**RE:** **315 North Ocean Breeze**

**TITLE:** **HRPB Project Number 22-00100169:** Consideration of a Certificate of Appropriateness (COA) for a new attached 1-car garage and a new 2-story wood-framed accessory building with a covered patio for a building located at 315 North Ocean Breeze; PCN# 38-43-44-21-15-096-0130. The subject property is a contributing resource within the Old Lucerne Historic District and is located in the Single Family Residential (SFR) zoning district. The future land use designation is Single Family Residential (SFR). A historic waiver is required to allow the accessory structure to exceed 40% of the principal structure.

**Exhibit 2 – Proposed Additions**

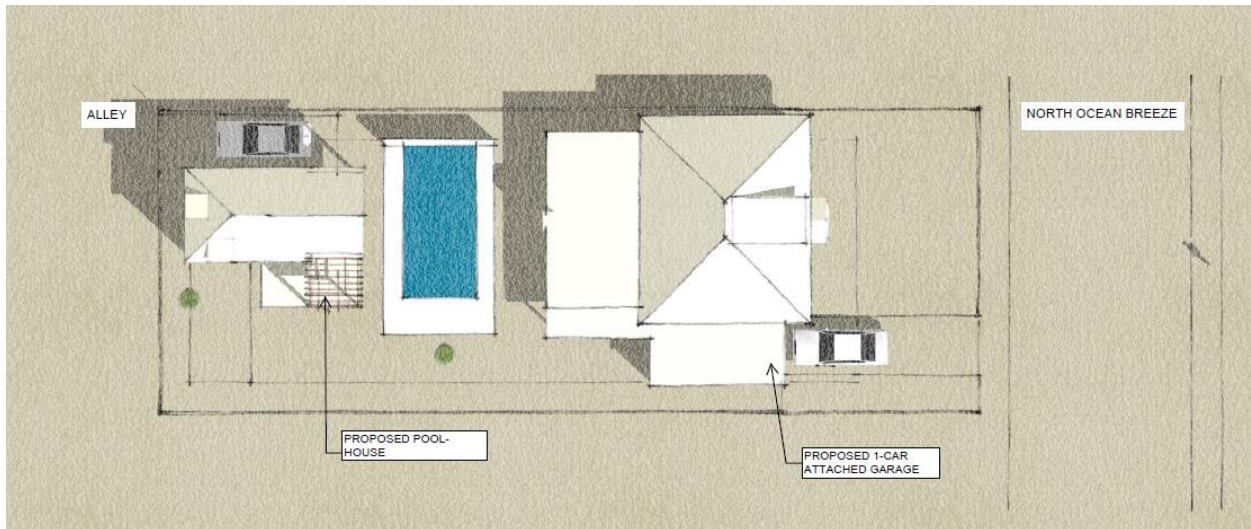
**STAFF RECOMMENDATION:** Staff recommends approval of the proposed exterior alterations and new construction. The proposed single car garage, loggia, and new 2-story accessory building is designed with materials and detailing that are consistent with the existing structure. With these criteria in mind, staff contend that these modifications are successful in complying with the City’s design guidelines and historic preservation ordinance. However, staff recommends the removal of the lattice-roof balcony on the south end of the proposed accessory structure, as this portion of the balcony is visible from the

street and contributes to the accessory structure exceeding the 40% limit imposed in the Land Development Regulations.

**Staff Analysis:** The size, massing, and other visual qualities of the proposed new construction are generally compatible and in harmony with visually related properties. However, staff recommend the removal of the lattice-roof balcony on the south end of the proposed accessory structure, as this portion of the balcony is directly visible from the street and contributes to the accessory structure exceeding the 40% limit imposed in the Land Development Regulations.

- 1) The existing trim shall remain where applicable. If any element is too deteriorated for continued use, it shall be replaced in-kind, subject to staff review at permitting.
- 2) The railing system used on the accessory structure's porches and balconies shall be architecturally consistent with the existing structure, subject to staff review at permitting.
- 3) New doors and windows shall be recessed within the wall, and shall not be installed flush with the exterior wall.
